**UGA DESIGN & CONSTRUCTION
SUPPLEMENTAL GENERAL REQUIREMENTS & STANDARDS
CHANGES FROM JANUARY 16, 2015 VERSION TO AUGUST 1, 2016 VERSION**

Office of the University Architects for Facilities Planning

TYPICAL DETAIL - FUME HOOD EXHAUST FAN SUPPORT FRAME
SCALE: NONE

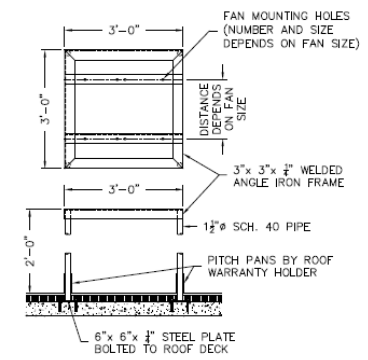
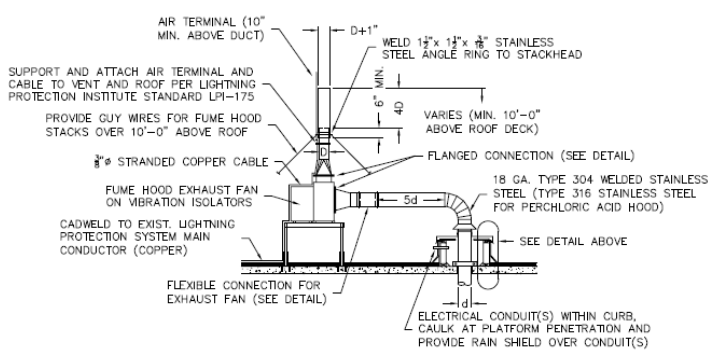
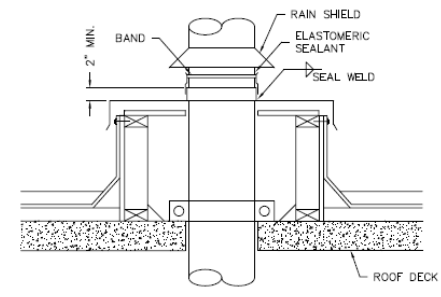
- 2.A.ii. Removed: Although, the use of air curtains are acceptable.
- 2.B.i. Edited: A sash stop shall be provided to permit a vertical opening of 18” from the counter top to top of the slotted opening located near the base of the sash.
- 2.B.ii. Edited: Sash shall be 3/16” thick laminated safety glass with an epoxy-coated aluminum sash handle.
- 2.B.iii. Edited: Sash counterbalanced system by a single weight: Chain and sprocket type.
- 2.I. Edited: Provide vacuum breaker on CW piping supply at gooseneck CW fixture inside fume hood.
- 2.L.i. Edited: Two-tube, rapid-start fluorescent light fixture of longest practicable length or equivalent LED fixture.
- 2.L.iv. Edited: Lamps: T-8 LED lamps.
- 2.L.vii. Edited: Set units so that lamps are replaceable from outside hood.
- 3.B. Replaced the roof curb for exhaust fan typical detail schematic drawing

FLEXIBLE CONNECTION FOR EXHAUST FAN
SCALE: NONE

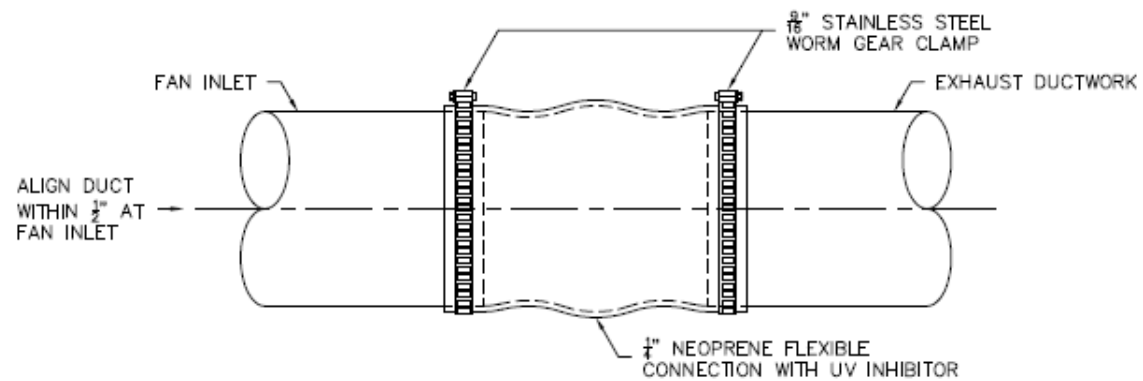
- 3.B. Added: Schematic drawing for flexible connection detail – typical for all fume hood exhaust fans.

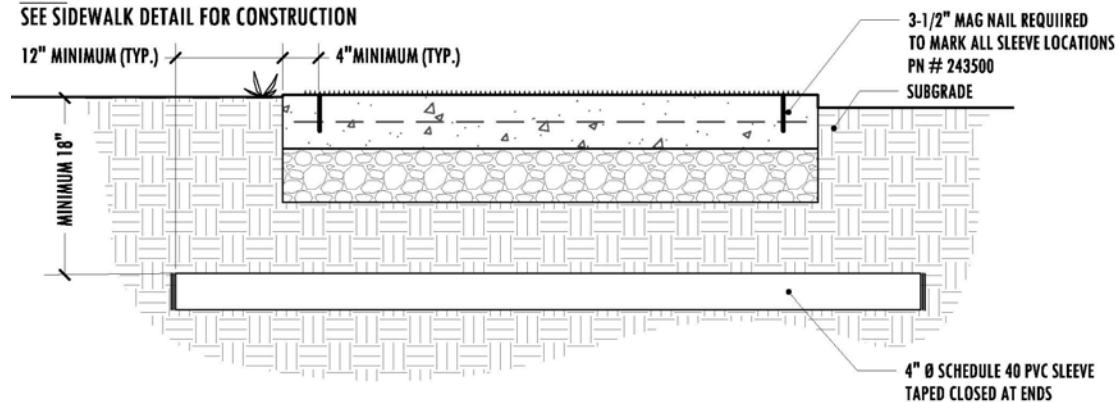
- 2.A.v. Edited: Piping changed from PVC Class 200 PSI to PVC Schedule 40.
- 2.B.v. Removed: Stub up sleeve pipe (12) inches above ground surface and cap. Paint cap with fluorescent orange paint for easy identification.
- 2.B.v. Added: All sleeves shall be marked with – 3-1/2” mag nail. Nail shall be placed 4” from edge of pavement on both sides as per the following detail (detail added).
